Project Name: Palm Court Plaza Temporary Modular Radiation Temporary

Request: Class III Site Plan Modification

---STAFF REPORT---

ITEM: Palm Court Plaza Temporary Radiation Therapy Facility – Class III Site Plan Modification and Architectural Elevations Associated with the Construction of a 3,441 square foot “temporary” radiation therapy modular building.

PALM COURT PLAZA
TEMPORARY RADIATION
FACILITY
PREPARED FOR
RAD TECHNOLOGY MEDICAL
SYSTEMS, LLC.
FLORIDA
DELRAY BEACH
SHEET NUMBER
L1.00

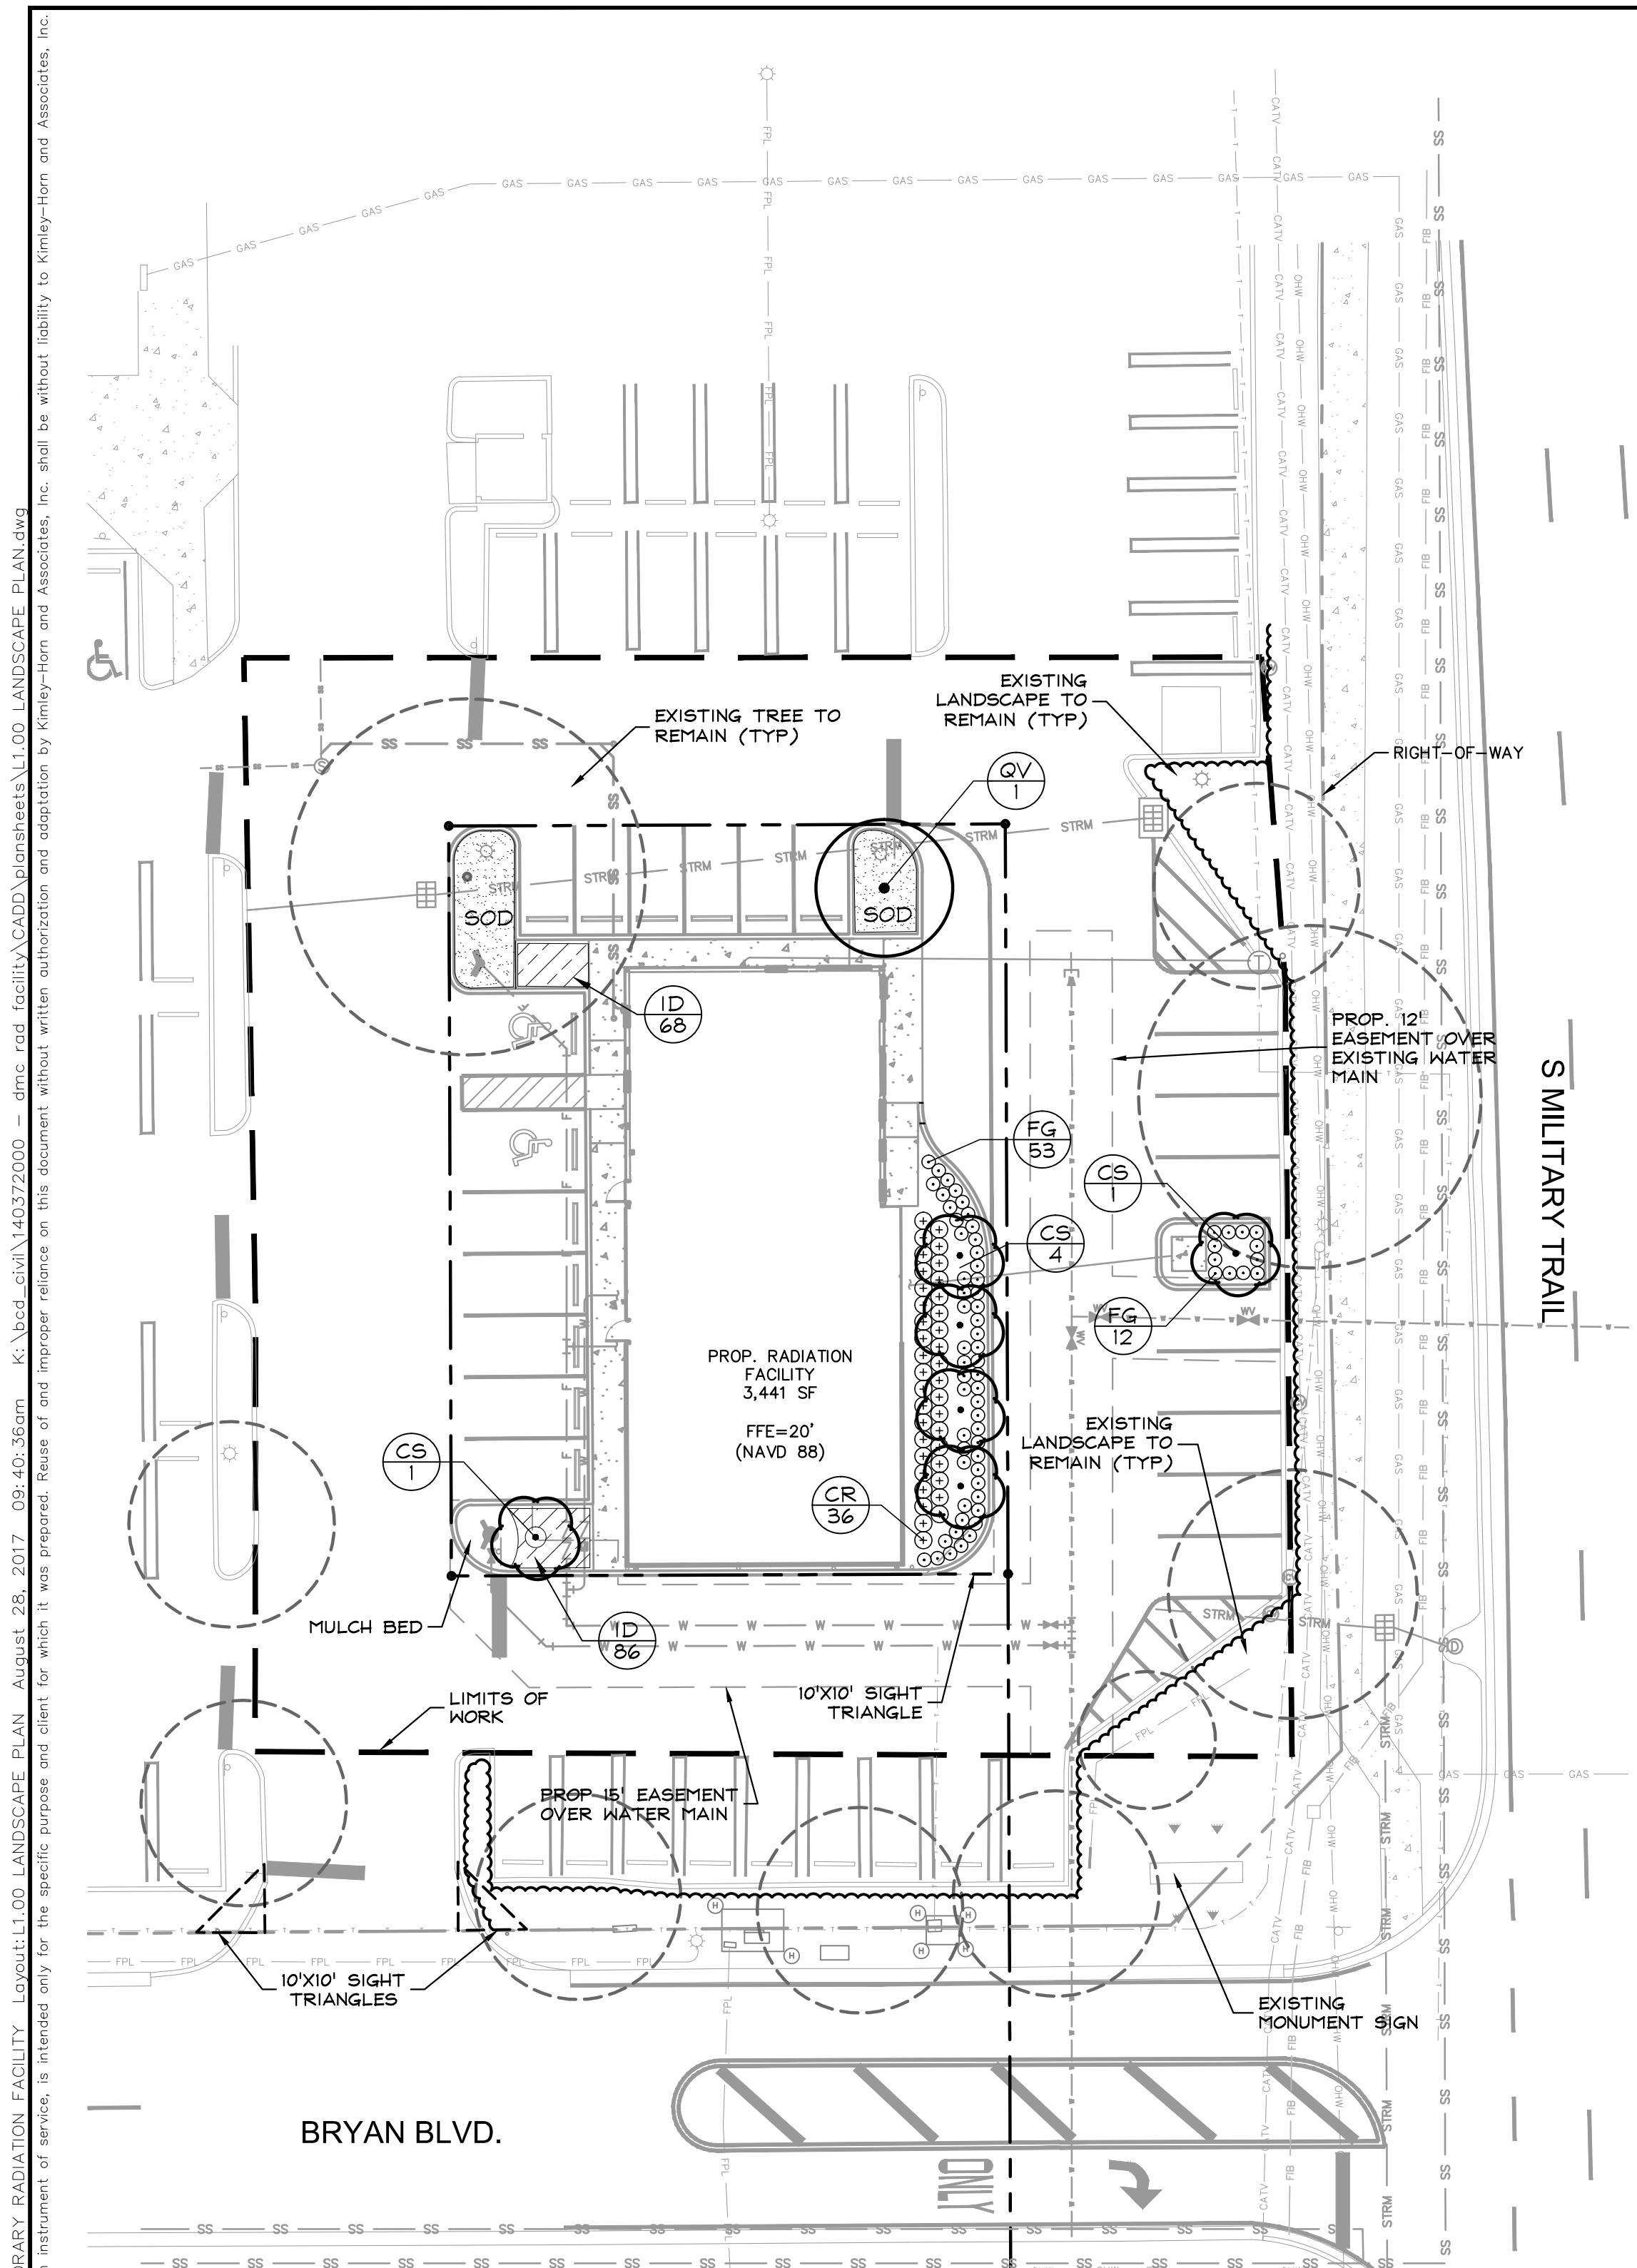
The landscape plan submitted has been evaluated by the City's Senior Landscape Planner. The landscape plan provides perimeter and building foundation material and calls for various native trees, shrubs and ground cover. The proposed landscape includes six Silver Buttonwoods, one Southern Live Oak, 36 Red Tip Cocoplum shrubs and 65 Green Island Ficus shrubs along with 167 dwarf Schillings Holly shrubs. The proposed landscape plan complies with the City's Land Development Regulations (Section 4.6.16). The development plan identifies numerous trees that will be removed. These are comprised primarily of Black Olive trees and one Live Oak. To the greatest extent possible, these trees should be relocated on the property. Consequently, a condition of approval is attached that a certified arborist report be submitted regarding the viability of relocating the native trees to other areas of the property and replace the proposed oak trees in the area of the proposed building.

1. That a certified arborist report be submitted regarding the viability of relocating the native trees to other areas of the property and replace the proposed oak trees in the area of the proposed building prior to site plan certification. The relocation of these trees shall be subject to the approval of Senior Landscape Planner.
